Rezoning Application: PD 25-0308

Development Services Department

1.0 APPLICATION SUMMARY

AGENCY REVIEW COMMENT SHEET

2.4 Proposed Site Plan (partial provided below for size and orientation purposes. See Section 8.0 for full site plan)

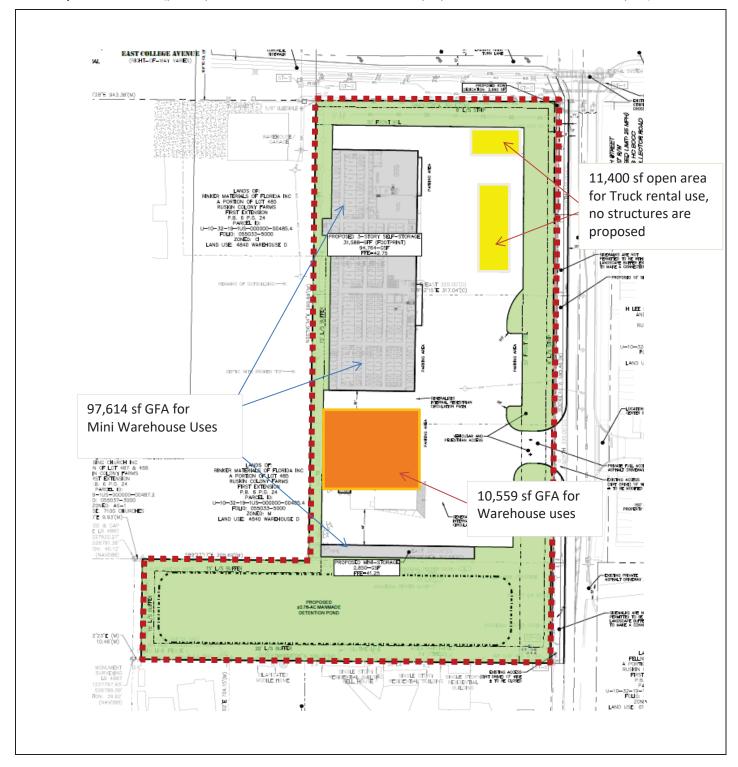
- 1. The project shall allow a warehouse, a 3-story self-storage facility, a 1-story mini warehouse, and truck and trailer rental.
- 2. The location of structures and rental areas shall be where shown on the site plan. Project development standards for the project shall be as following:

- 7. The project shall be permitted one full access connection on 27th St., as shown on the PD site plan.
- 8. If PD 25-0308 is approved, the County Engineer will approve a Design Exception (dated April 7, 2025) which was found approvable by the County Engineer (on April 8, 2025) for 27th St. SE substandard road improvements. As 27th St. SE is a substandard collector roadway, the developer shall make the following improvements consistent with the Design Exception in lieu of constructing the roadway to typical standard:

- 1. Site Plan (Revised)
- 2. Transportation Technical Manual TS-4 Exhibit
- 3. Typical Section Curb and Gutter
- 4. Proposed Typical Section

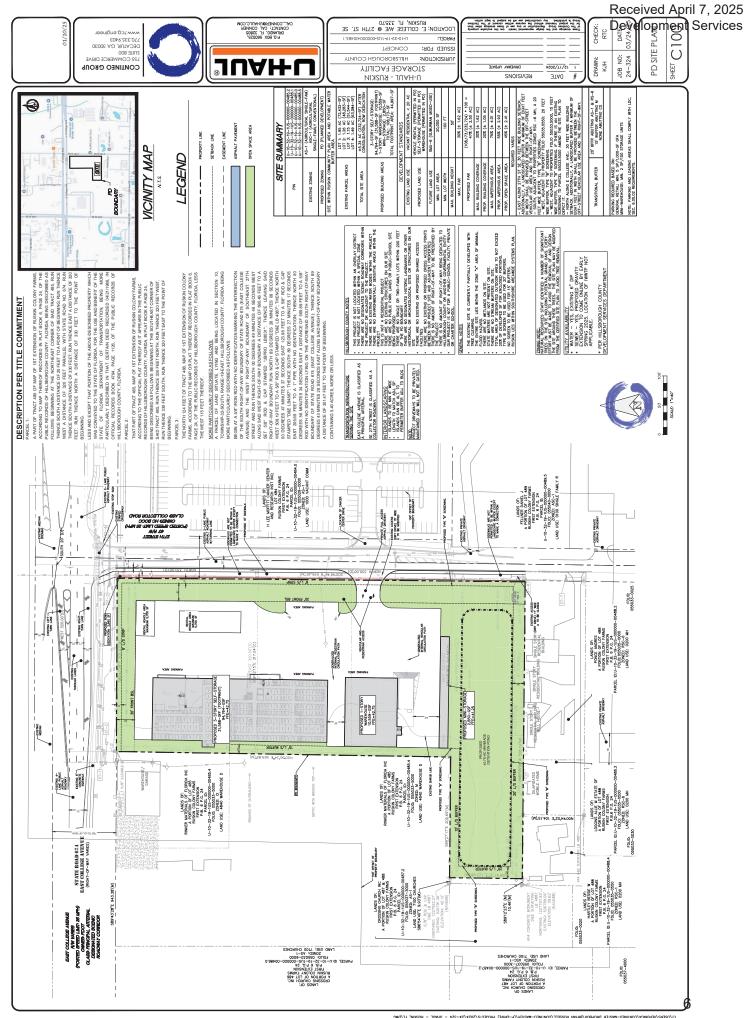
- 1. Provide a 24" curb and gutter along the west side of SE 27th Street. The limits of improvement are 696 feet of curb and 699 feet of gutter.
- 2. Provide a 10-foot wide multi-use sidewalk along the west side of SE 27th Street. The total length of this improvement is 655 feet.
- 3. Dedication of approximately 2,660 SF of right-of-way. The ROW dedication width varies in range between 2 and 6 feet.

- 1) TS-4 has 64 feet of right-of-way. The right-of-way along the property frontage is approximately 71 feet. ROW is not substandard.
- 2) TS-4 has sidewalks along both sides of SE 27th Street. There is no current sidewalk along the road frontage for the proposed U-Haul Development. The revised plan calls for a 10-foot wide sidewalk.

- 1) The U-Haul development proposes dedication of approximately 2,660 feet of right-of-way. The ROW dedication width varies in range between 2 and 6 feet.
- 2) Provide a 24" curb and gutter along the west side of SE 27th Street
- 3) Provide a 10-foot wide multi-use sidewalk along the west side of SE 27th Street. The design exception shall include all elements of TS-4.

The attached DE is **Approvable** to me, please include the following people in your response:

- 1. Site Plan (Revised)
- 2. Transportation Technical Manual TS-4 Exhibit
- 3. Typical Section Curb and Gutter
- 4. Proposed Typical Section

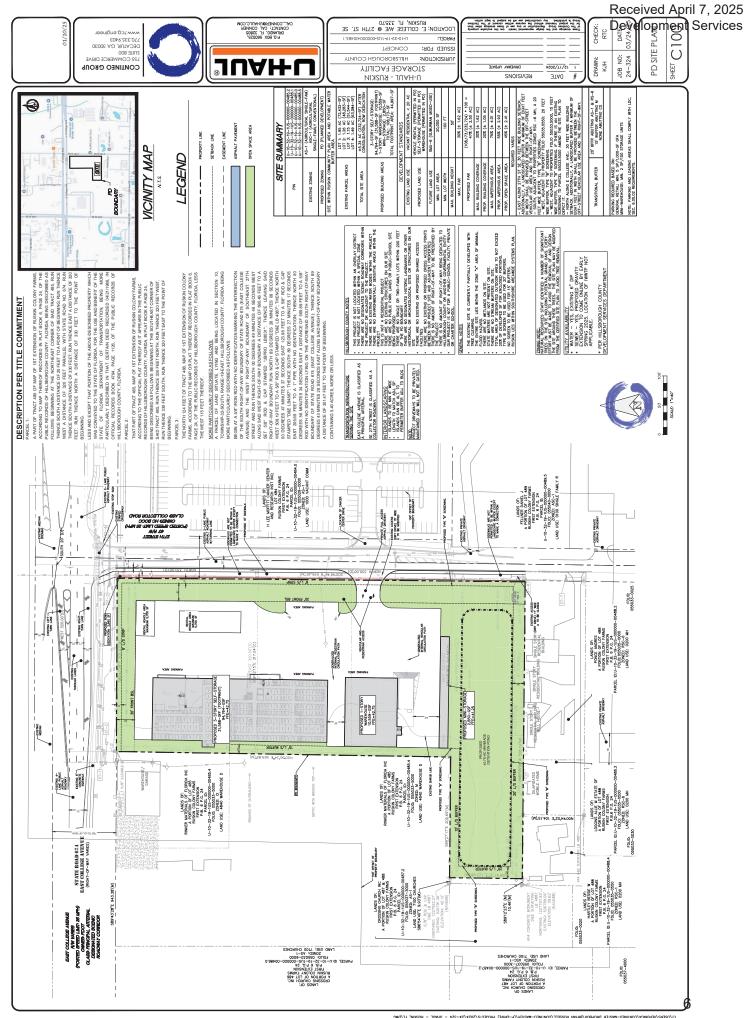
- 1. Provide a 24" curb and gutter along the west side of SE 27th Street. The limits of improvement are 696 feet of curb and 699 feet of gutter.
- 2. Provide a 10-foot wide multi-use sidewalk along the west side of SE 27th Street. The total length of this improvement is 655 feet.
- 3. Dedication of approximately 2,660 SF of right-of-way. The ROW dedication width varies in range between 2 and 6 feet.

- 1) TS-4 has 64 feet of right-of-way. The right-of-way along the property frontage is approximately 71 feet. ROW is not substandard.
- 2) TS-4 has sidewalks along both sides of SE 27th Street. There is no current sidewalk along the road frontage for the proposed U-Haul Development. The revised plan calls for a 10-foot wide sidewalk.

- 1) The U-Haul development proposes dedication of approximately 2,660 feet of right-ofway. The ROW dedication width varies in range between 2 and 6 feet.
- 2) Provide a 24" curb and gutter along the west side of SE 27th Street
- 3) Provide a 10-foot wide multi-use sidewalk along the west side of SE 27th Street. The design exception shall include all elements of TS-4.

The attached DE is **Approvable** to me, please include the following people in your response:
